SW - 1

**THIS .75 ACRE SITE WILL BE A DAY CARE CENTER  
ALL THE RUN OFF WILL BE DIRECTED TO THE  
PEVIOUS PAVERS AND THEN PIPED TO THE  
DRAINAGE SYSTEM ON MORRISON ST.**

SWP PLAN

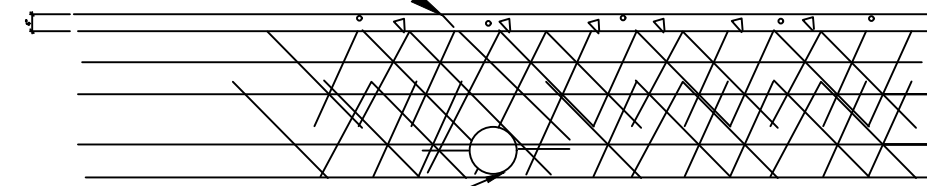
THIS AREA OF EXISTING DEVELOPMENT IS PART OF THIS PROJECT AND MUST BE INCLUDED IN CAPTURE VOLUME

EXISTING DEVELOPMENT ON THIS SIDE OF THE LOT LINE MAY ALSO BE CONSIDERED TO BE PART OF THIS PROJECT aka DEVELOPMENT SITE. Provide justification for consideration as a separate Development Site.

PROVIDE  
MORE  
DETAIL

THIS  
NUMBER  
NEEDS TO BE  
32,546 IF THE  
STATEMENT  
ABOVE IS  
CORRECT.
